MEMORANDUM

INFORMAL DISCUSSION #1 MEETING OF 05-13-21

To: Conservation Commission/Inland Wetlands and Watercourses Agency

Re: Proposed 8-lot Subdivision at 1040 Main Street (across from Southgate Drive) – 8 frontage lots and some 650 feet of new public road (with a permanent cul-de-sac) on 9.3 acres – Residence AA Zone and Groundwater Protection (overlay) Zone 1 – Alter & Pearson, LLC – Davison Environmental, Soil and Wetland Scientist and Wildlife Biologist – Wolff Engineering, C.E. – Carrier Construction, Inc., landowner/applicant

Site in relation to existing, nearby open space & easements (conservation & drainage)

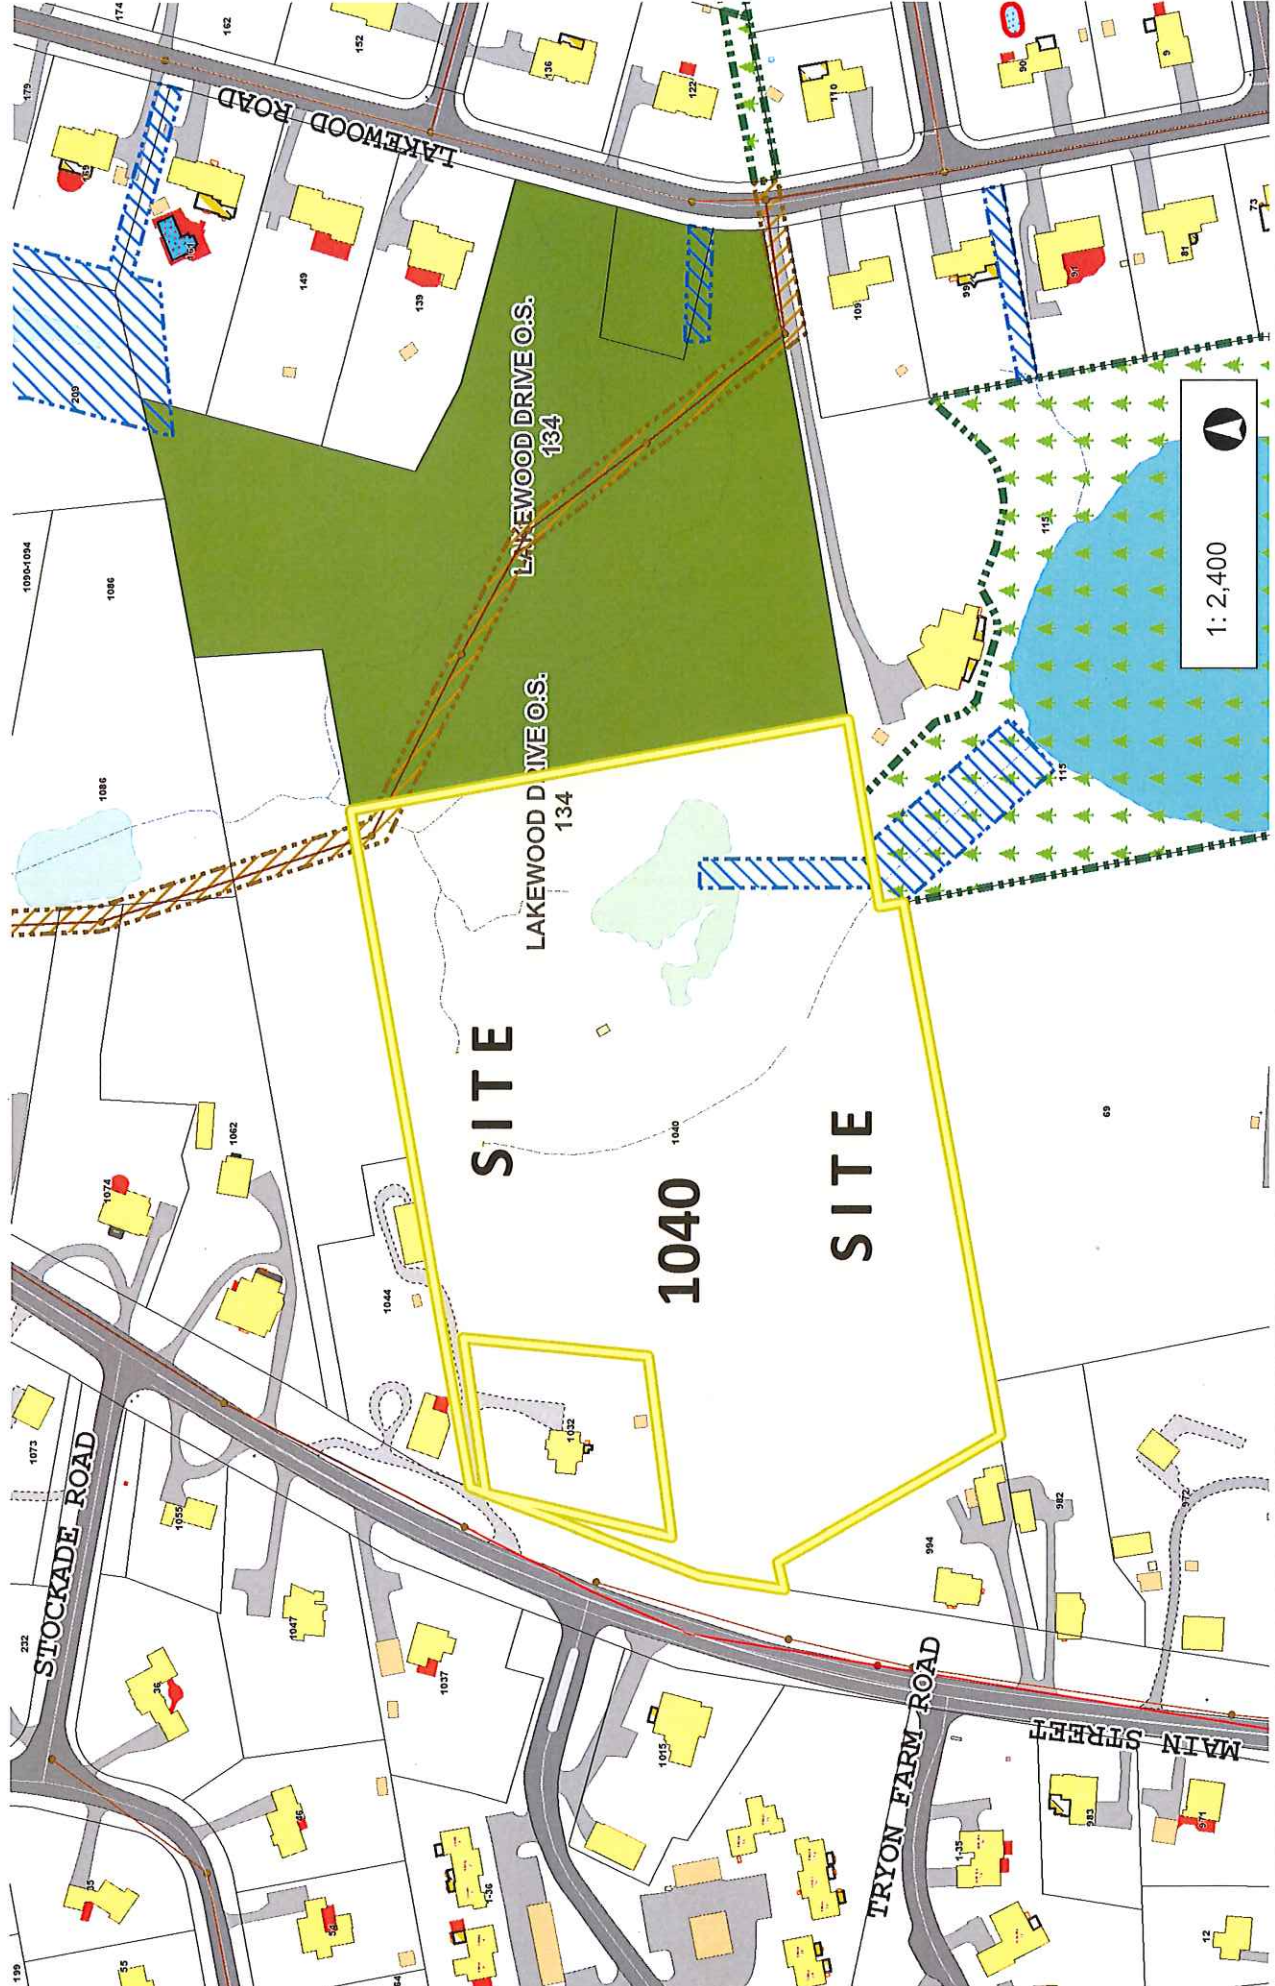
Staff recommends an expansion of the proposed conservation easement area in order to protect the steep slopes that immediately surround the wetlands and to provide a long term vegetated filter strip (of a minimum of 25 feet beyond the wetlands limits).
